**20096-03-001**

**Proposed Residential Development  
at Finlay Park, Nass, Co. Kildare**

**ROAD SAFETY AUDIT STAGE 1 / 2**

**November 2022**

### 2.2 Problem

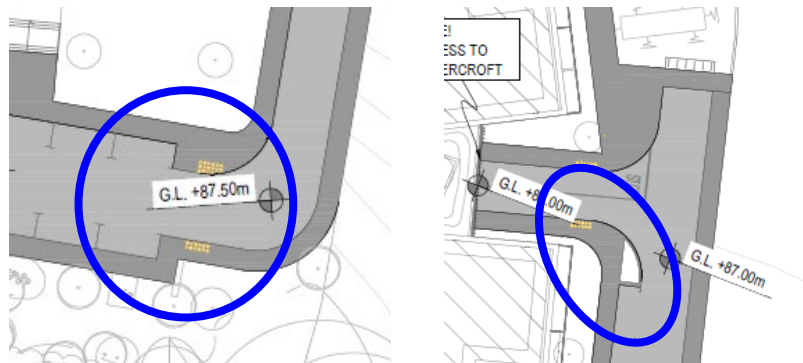
A number of uncontrolled pedestrian crossing locations are proposed throughout the development. However, it is unclear whether adequate inter-visibility is provided between drivers of vehicles approaching the pedestrian crossings and pedestrians stopped waiting to cross at the pedestrian crossings. Obstructions to visibility may include parked vehicles adjacent to the pedestrian crossings.

Adequate inter-visibility should be provided between drivers of vehicles approaching the pedestrian crossings and pedestrians stopped waiting to cross at all the pedestrian crossings.

2.2	Yes	Yes	1 parking space has been removed at the southeast corner of the site, in order to provide adequate stopping sight distance around the bend. The location at the car parking garage will have very low speeds (<10kph) and infrequent use by pedestrians, as this is the back side of the apartment building. We are satisfied with the visibility in this location.	-----

**2.3 Problem**

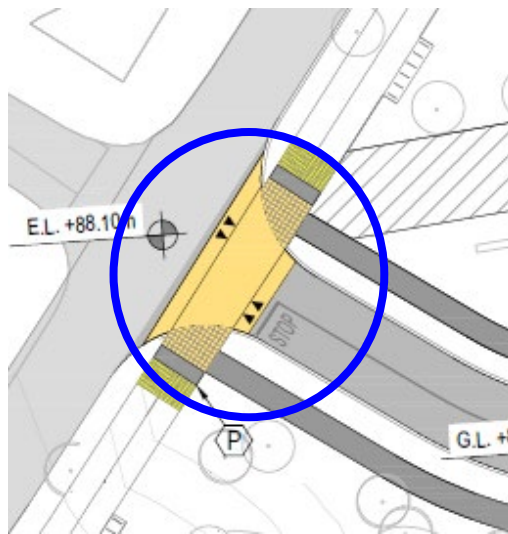
At the exit from the development the stop line is located to the back of the proposed footpath / cyclepath. Drivers of vehicles stopping at this location may not have adequate visibility of approaching vehicles on Finlay Park access road. If a driver advances from the stop line and exit the development without checking again for oncoming vehicles on Finlay Park access road, then this may lead to a side impact collision at the exit.

Ensure adequate visibility splays are provided at the access from the proposed stop line or advance the stop line to the edge of Finlay Park access road.

2.3	Yes	Yes	In the proposed layout cyclists and pedestrians have the priority, which is in accordance with DMURS Section 4.4.5. A visibility splay from the stop line has been added to drawing C-055 and we are satisfied that adequate visibility splays are provided.	-----

**2.4 Problem**

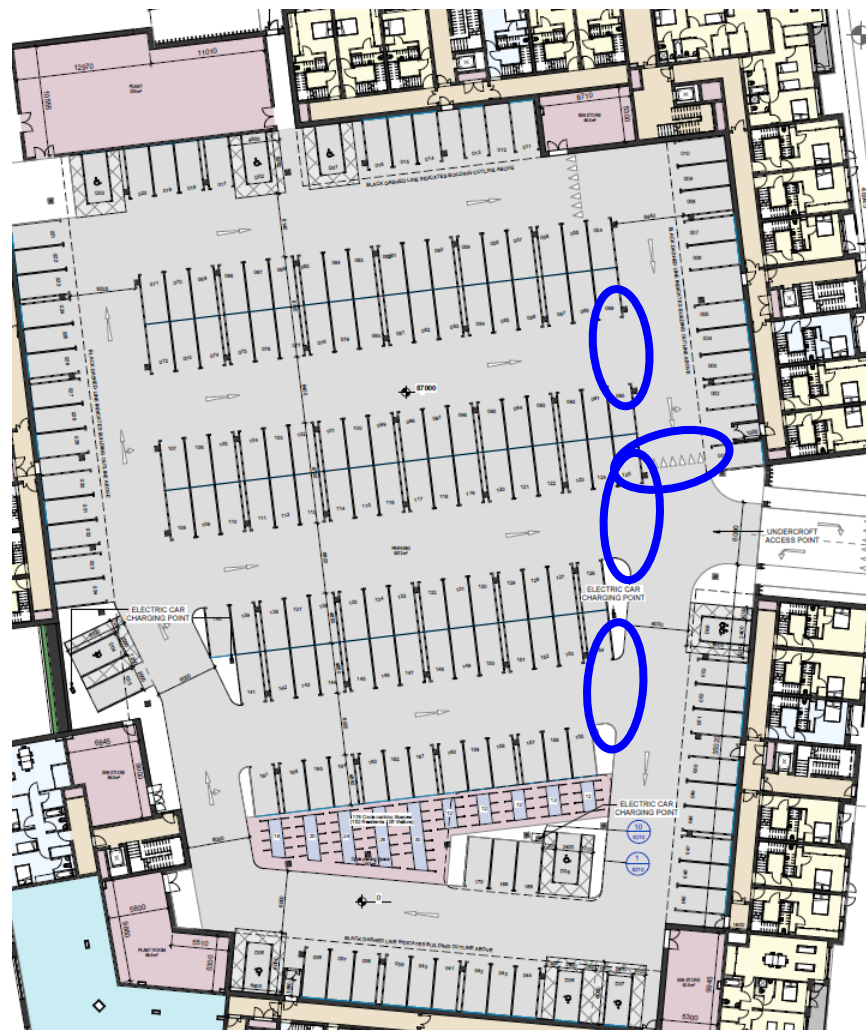
The proposed underground car park is shown to operate as a one-way system. However, at the end of the aisles adequate markings and signage are not shown to be provided to inform drivers of vehicles of the one-way system, in particular at the entrance to the underground car park which may result in a collision at these locations.

Provide adequate road markings and signage to inform drivers of the one-way circulating system within the underground car park.

2.4	Yes	Yes	NO ENTRY road markings have been added accordingly within the underground car park and a left-turn only sign has been added at the entrance to the underground car park.	-----
